RE: BUN60419132 – 3 Pigeon Mountain Road, Half Moon Bay

Thank you for your letter dated 10 July 2025 requesting further information relating to the above resource consent application.

Section 92 Request for Further Information: BUN60419132 – HND HMB Limited	Applicant Response	Council Response
Plan Consistency		
<p>a. The revised plan sets include a large number of inconsistencies. Please provide updated drawing sets that illustrate a consistent proposal. This includes, but is not limited to:</p> <ul style="list-style-type: none"> a. Providing consistent JOALs numbering. The engineering drawings consider the JOAL between Units 12 to 41 to be a single JOAL (“JOAL 2”), but the architectural drawings show this as two JOALs (“JOAL 2” and “JOAL 3”), resulting in the subsequent JOAL numbering being inaccurate. In addition, the Urban Design Assessment refers to JOAL 7, which is not referenced elsewhere. b. Providing consistent retaining wall locations and heights. This includes, but is not limited to: <ul style="list-style-type: none"> i. The architectural and landscape drawings show a proposed retaining wall to the western boundary, but the civils plans show this only as existing. ii. T

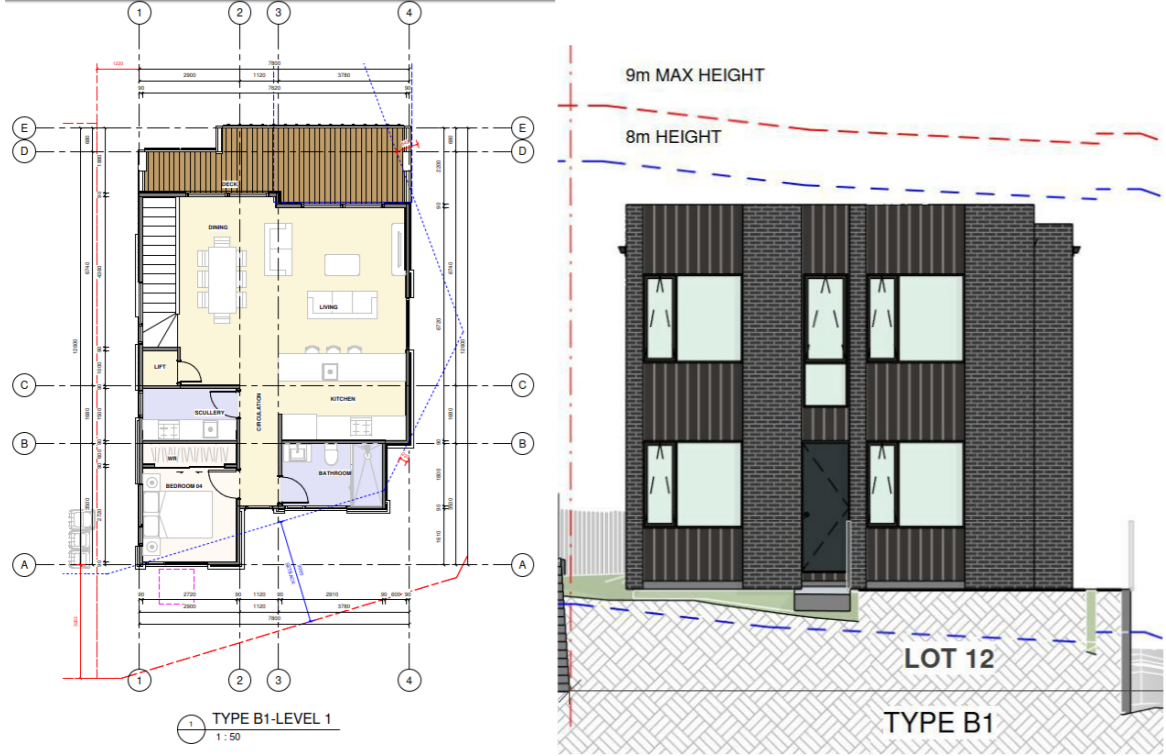
<p>13. Please clarify the purpose of the runoff diversion bunds (shown on the ESCP in red).</p>	<p>Eighty6: Please refer to the revised drawing FP326-220. The legend has been updated, the dirty-water diversion channels and bunds now represented by the blue arrows. Red line indicates the catchpit inlet protection (sand socks).</p> <p>Dirty water diversion channels and bunds have been incorporated into the erosion and sediment control design in accordance with GD05 Section E2.2. These structures are positioned upstream of the silt fences to</p>

Section 92 Request for Further Information: BUN60419132 – HND HMB Limited	Applicant Response	Council Response									
	<p>intercept sediment-laden runoff, reduce flow velocity, and direct water to SRP a located at the northern corner.</p> <p>To enhance sediment capture, a drop-out pit may be installed prior to the SRP to allow heavier particles to settle. Downstream of the bund, a silt fence is proposed as a secondary safeguard, providing additional protection in the event of bund failure or overtopping.</p> <p>This approach aligns with GD05’s “treatment train” philosophy, ensuring multiple layers of sediment control and minimising environmental impact on the receiving stormwater system.</p>										
14. Please update the notes section to reflect the proposed sediment controls.	Eighty: Please refer to the updated Sediment and Erosion Control Plan DWG FP326-220.										
15. Please discuss whether a 3% SRP will be more suitable given the slope of the site.	<p>Eighty6: The size of SRP has been designed considering the contributing catchment area and slope length. Table below summarised the pre- and post- construction slope. The slope does not greater than 18% and the slope length of the contributing catchment is 130m (less than 200m). SPR size to 2% of the contributing catchment area is therefore proposed in line with GD05 SPR design criteria</p>

Pre-construction	Post-construction	Average slope over contributing catchment	10%	5%	Slope immediately (within 20m) above the SRP	10%	6%	
	Pre-construction	Post-construction									
Average slope over contributing catchment	10%	5%									
Slope immediately (within 20m) above the SRP	10%	6%									
16. Please update the SRP size details to clarify the length and width of the pond when measured at the primary spillway (to demonstrate it will meet the 3:1 L:W ratio). Please update the SRP on the drawing to reflect any change in dimensions.	Eighty6: Please refer to the dimension table in the updated Sediment and Erosion Control Plan (DWG FP326-220), which confirms that the SRP meets the required 3:1 length-to-width ratio. These dimensions have also been added to the drawing.										
Tree works											
17. The path to and deck of Unit 10 are located within the Protected Root Zones of pohutukawa trees in the open space between the site and Ara Tai. Please provide an assessment against E16 of the AUP, which may require an arborist report to be prepared.	Works within the vicinity of the pohutukawa trees has been revised. Please also refer attached arboriculture report by Tree3, confirming the works are within the permitted thresholds.										
18. Please clarify whether any earthworks will be located within the protected root zone of trees that are to be retained.	As above, works within the vicinity of the trees has been revised including on the earthworks plans.

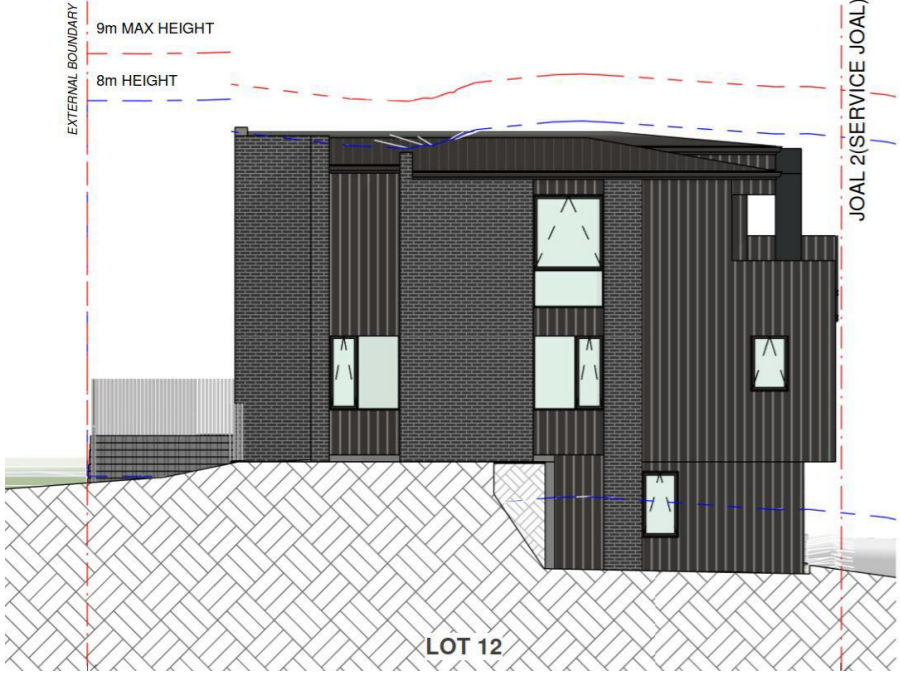
<p>23. The drawing titled “Retaining wall Layout Plan” prepared by Eighty6 Civil Engineering, Drawing FP326-260, rev A, dated 28 February 2025 indicates six proposed retaining walls RW1 to RW6 in close</p>

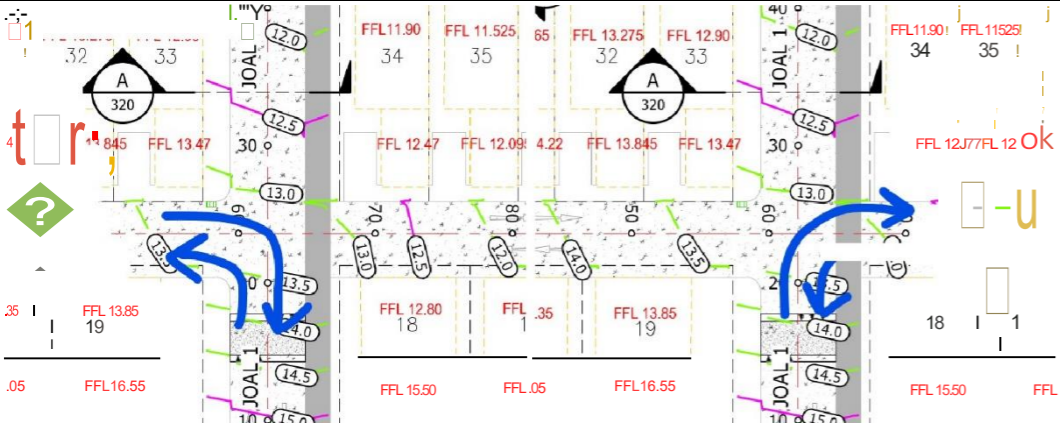
37. Please correct the positioning of the outlook spaces for the principal living room and principal bedroom for the Type A2 unit typology so that they are centred on the applicable window.	Centred outlooks shown on Outlook Plan (Drawing A2.10 & A2.11).

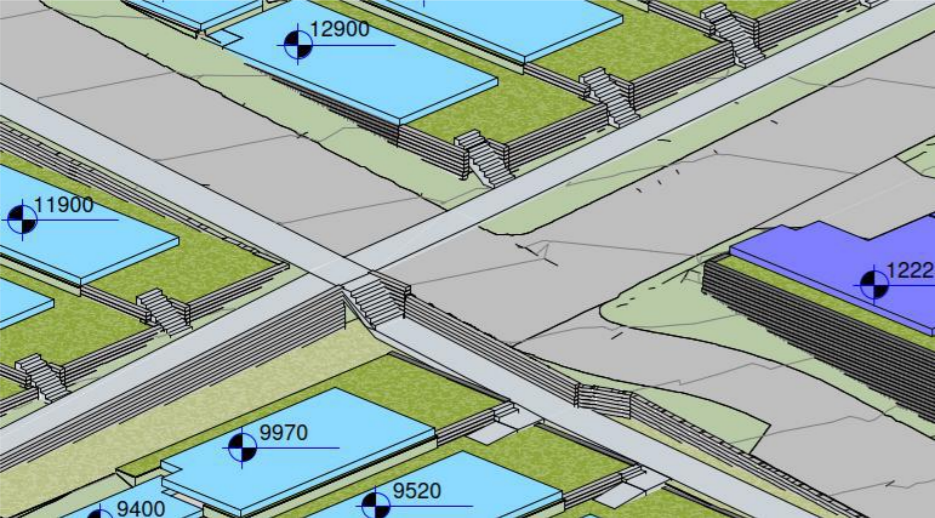
48. Please provide dimensions of the deck provided for Unit 11 (the Type E1 unit typology). Please then provide an assessment of whether this deck alone provides for an outdoor living space that is of a	Same as Q47.

Section 92 Request for Further Information: BUN60419132 – HND HMB Limited	Applicant Response	Council Response
functional size and dimension (given that the adjacent ground area is not a suitable grade for outdoor living).

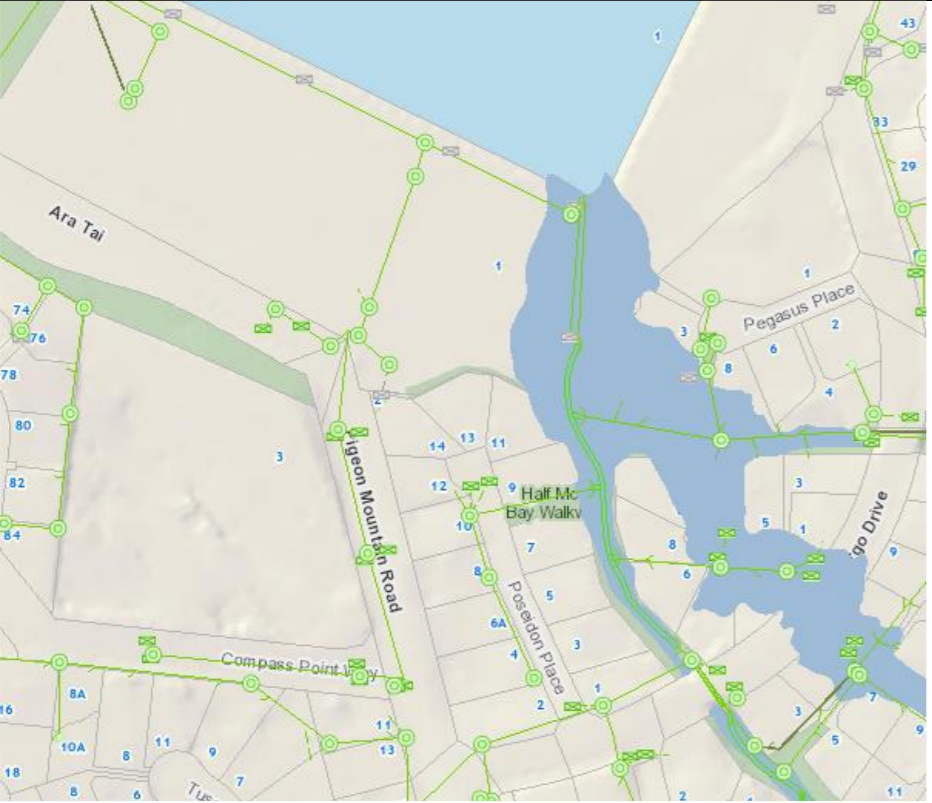
<p>98. Please identify how residents will be preventing from parking a second vehicles in front of garages where the setback from the legal JOAL is less than 10 m, but the setback from the formed JOAL is not less than 9.8 m (which would allow for two 85th percentile vehicles). In particular:</p>	<p>Units 56 and 57 have been revised in design and have a set back of 5m between the garage and the JOAL.</p>

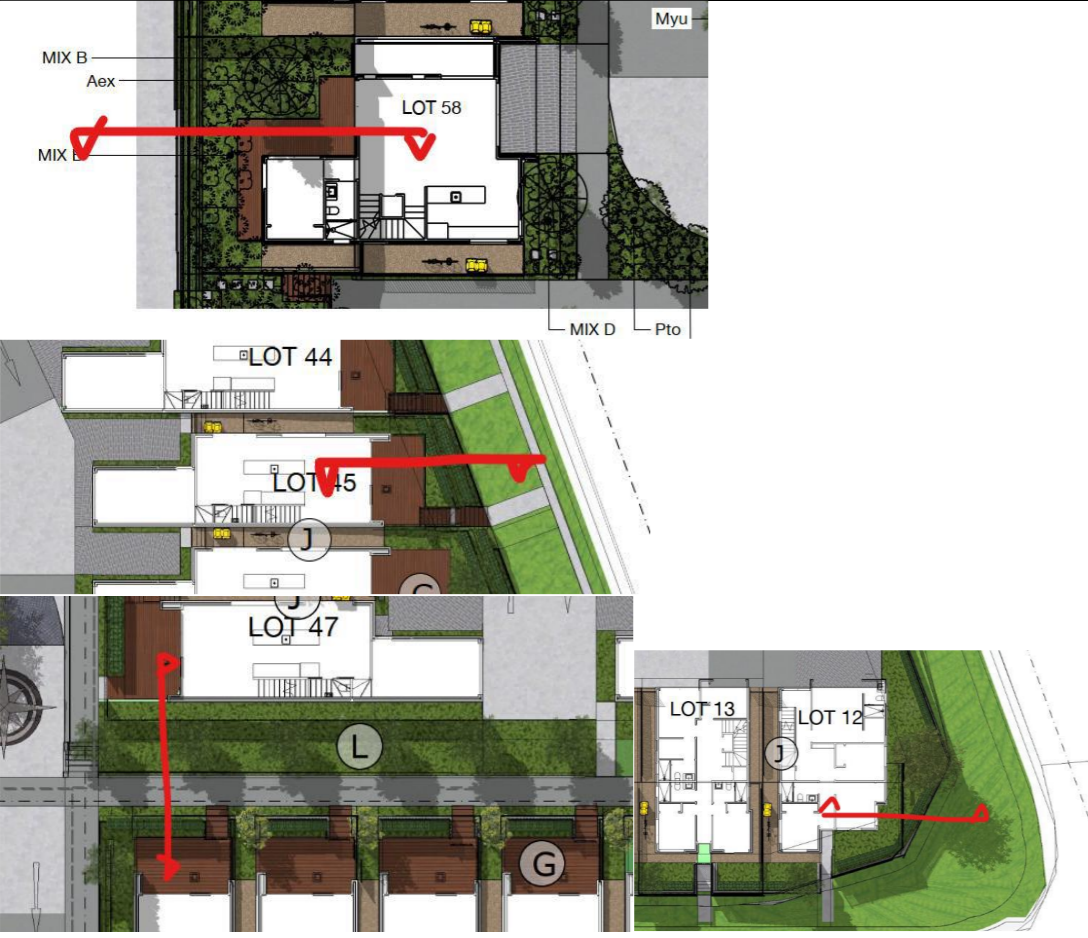
<p>108. The scheme plan does not include any maintenance easements where boundaries are proposed within 1 m of the face of a building. Please specific why these are not required or otherwise update the scheme plan to include these.</p>	<p>Easements have been added.</p>	
<p>109. If pedestrian access to Units 47 to 50 onto the adjacent footpath is shared, easements will be required or the COAL boundary would need to be amended. Please clarify.</p>	<p>Revised layout has footpath within COAL</p>	
<p>110. Please clarify why the boundary of Lot 103 is located at the face of the garages of Units 47 to 49 but set back from the garages of Units 44 to 46.</p>	<p>On new scheme the boundary is 0.1m from the garage face.</p>	
<p>111. The proposed subdivision plan includes four commonly owned access lots, being Lots 100 to 103.</p> <p>The previous iteration of the proposal had proposed a single COAL. Item 98 of the original section 92 queried the appropriateness of this arrangement given that the COAL included a number of areas that were not intended to be trafficable by vehicle, which would conflict with the rights provided for in section 298 of the Property Law Act 2007.</p> <p>Lots 101 to 103 of the current proposal contain almost exclusively areas that are intended to be trafficable by vehicles and therefore their provision as COALs can be accepted.</p> <p>However, Lot 100 contains footpaths, landscaped areas, cycle storage areas, rubbish bin storage areas and other areas that should not be trafficable by vehicles. Therefore, the rights provided to a COAL under section 298 of the Property Law Act 2007 are not appropriate across the full extent of this lot. Therefore, for that area currently within Lot 100, please either:</p> <p>a. Create additional commonly owned lots for non-trafficable areas, separate to a COAL for the trafficable areas. Section 298 of the Property Law Act 2007 would not apply to a commonly owned lot that does not contain vehicle access; or</p>	<p>Lot 100 is main thoroughfare – used by all Lots 101/102 are specific to Lots being served and thus differentiated</p> <p>Lot 100 has been provided an easement in favour of Lots 1 to 62.</p>
